# Access Compliance Report

## Public Rights-of-Way

### (Curb Ramps)

Intersection ID: 20284	Main Street: LANSLOWNE_RD	Cross Street: MORVEN_LN	Location: S
ADA ID: 71BFCC9D5836	Ramp Type: PerpDiag	Initial Pass/Fail: Fail	Overall Compliance: No
		Severity Score: 1.25

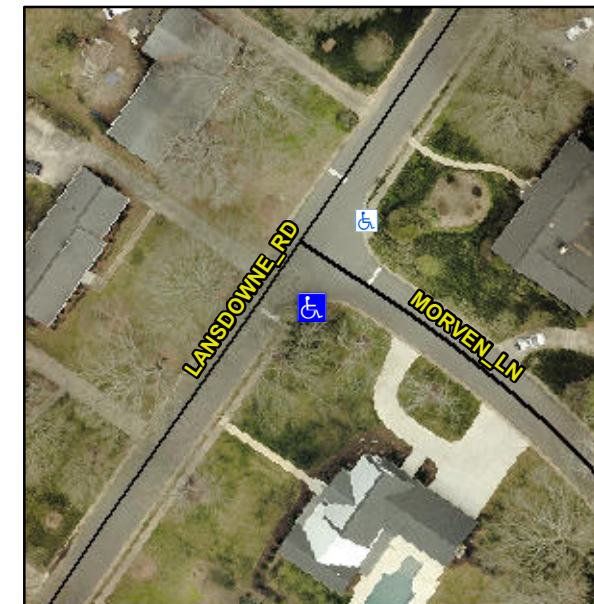
**Not Found, R304.5.3**

Compliance	Description	Data	Compliance	Description	Data
N/A	Ramp Length (in)	50.0	Yes	Ramp Slope (%)	8.1
Yes	Ramp Width (in)	50.0	No	Ramp XSlope (%)	2.8
N/A	Flare Type LT	N/A	N/A	Flare Type RT	N/A
N/A	Flare Slope LT (%)	N/A	N/A	Flare Slope RT (%)	N/A
N/A	Flare Traversable LT?	N/A	N/A	Flare Traversable RT?	N/A
N/A	Landing Length (in)	N/A	N/A	DWS Provided?	N/A
N/A	Landing Width (in)	N/A	N/A	DWS Contrast?	N/A
N/A	Landing Slope (%)	N/A	N/A	DWS Length (in)	N/A
N/A	Landing X Slope (%)	N/A	N/A	DWS Full Width?	N/A
N/A	Landing Curb? (Y/N)	N/A	N/A	DWS Offset (in)	N/A
N/A	Shared Landing?	N/A			
N/A	Gutter Ponding?	N/A	N/A	Gutter Slope (%)	N/A
N/A	Gutter Lip Ht (in)	N/A	N/A	Gutter X Slope (%)	N/A
N/A	Painted X Walk1?	No	N/A	Painted X Walk2?	No
	X Walk 1 Direction	To NE		X Walk 2 Direction	To NW
N/A	X Walk 1 Width (in)	N/A	N/A	X Walk 2 Width (in)	N/A
	X Walk 1 Slope (%)	3.0		X Walk 2 Slope (%)	4.3
	X Walk 1 X Slope (%)	3.2		X Walk 2 X Slope (%)	2.1

**Remove & Replace Curb Ramp With Two New Directional Ramps or Equivalent.**
